### **REMARKS**

The enclosed is responsive to the Examiner's Office Action mailed on February 18, 2005. At the time the Examiner mailed the Office Action claims 1-28 were pending. By way of the present response the Applicants have not amended or canceled any claims. As such, claims 1-28 remain pending. The Applicants respectfully request reconsideration of the present application and the allowance of all claims.

FIG. 2  
(PRIOR ART)

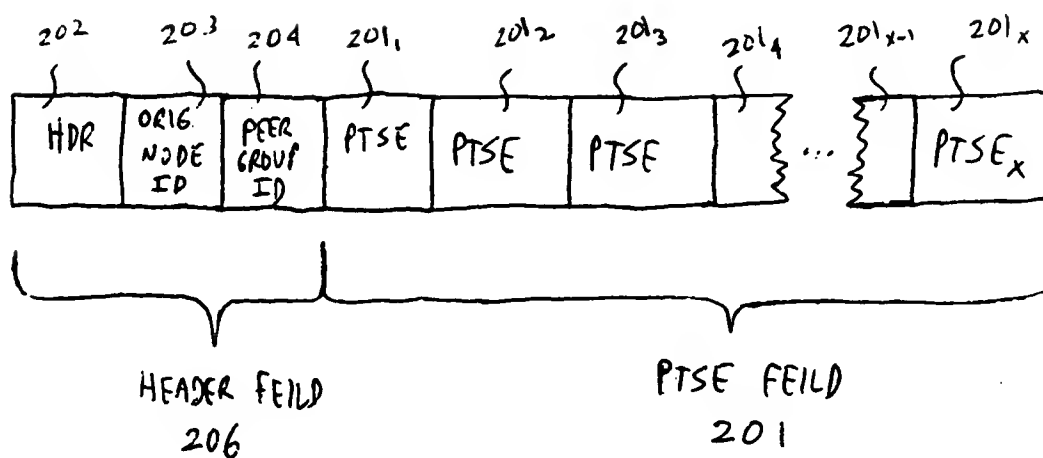
The Examiner has objected to the figures generally for "lack of legends" but has not elaborated on the deficiencies on the legends as filed (see, Examiner's Office Action mailed 2/18/05, pg. 2). The Applicant has included the legend "prior art" to Figures 2 and 3. The Applicant respectfully requests the Examiner to specify what additional legends are required.

Figures 2 and 3 have been amended so as to further include the legend  
“prior art”.
